Access Compliance Report

Public Rights-of-Way

(Curb Ramps)

Intersection ID: 13310	Main Street: COSBY_PL	Cross Street: GRAYBARK_AV	Location: NE
ADA ID: 109E183C3DD1	Ramp Type: Perp	Initial Pass/Fail: Fail	Overall Compliance: No
			Severity Score: 21.25

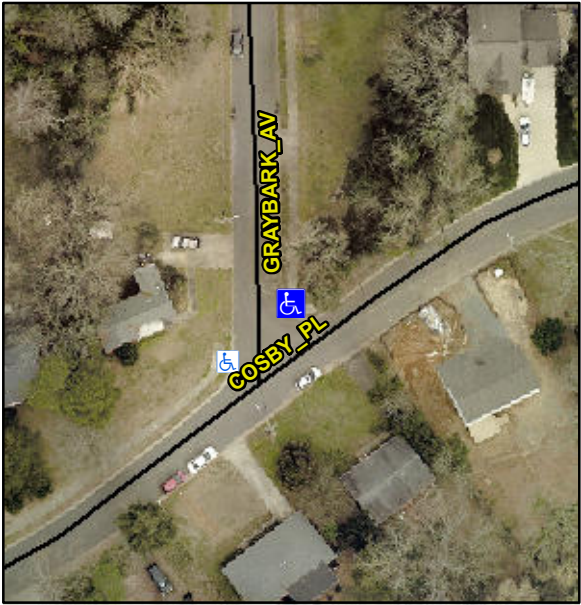
Codes/Mitigation Info/Possible Solution			Field Measurements/Component Compliance		
	Possible Solutions:		Compliance	Description	Data
	Remove & Replace Entire Ramp.		Yes	Ramp Length (in)	24.0
			No	Ramp Width (in)	37.0
			N/A	Flare Type LT	N/A
			N/A	Flare Slope LT (%)	N/A
			N/A	Flare Traversable LT?	N/A
			N/A	Landing Length (in)	N/A
			N/A	Landing Width (in)	N/A
			N/A	Landing Slope (%)	N/A
			N/A	Landing X Slope (%)	N/A
<p>Surveyor Notes:</p> <p>N/A</p> <p>PROW/ADA:</p> <p>Not Found, R304.5.1, R304.5.3</p>			N/A	Flare Type RT	N/A
			N/A	Flare Slope RT (%)	N/A
			N/A	Flare Traversable RT?	N/A
			N/A	DWS Provided?	N/A
			N/A	DWS Contrast?	N/A
			N/A	DWS Length (in)	N/A
			N/A	DWS Full Width?	N/A
			N/A	DWS Offset (in)	N/A
			N/A	Shared Landing?	N/A
			N/A	Gutter Ponding?	N/A
			N/A	Gutter Lip Ht (in)	0.5
			N/A	Painted X Walk1?	No
				X Walk 1 Direction	To SW
			N/A	X Walk 1 Width (in)	N/A
				X Walk 1 Slope (%)	0.5

X Walk 1 X Slope (%)	4.6
			N/A	Ramp inside XWalk1?	N/A
			N/A	Road Slope (%)	N/A
			N/A	Road X Slope (%)	N/A
			N/A	Any Obstructions?	N/A
				Obstruction Type	
			N/A		
			N/A		
			N/A		
			N/A		
			N/A		
			N/A		
			N/A		
			N/A		
			N/A		
Total Cost:		\$ 1850.00			
			N/A		
			Yes	Surface Condition? (G/P)	Good
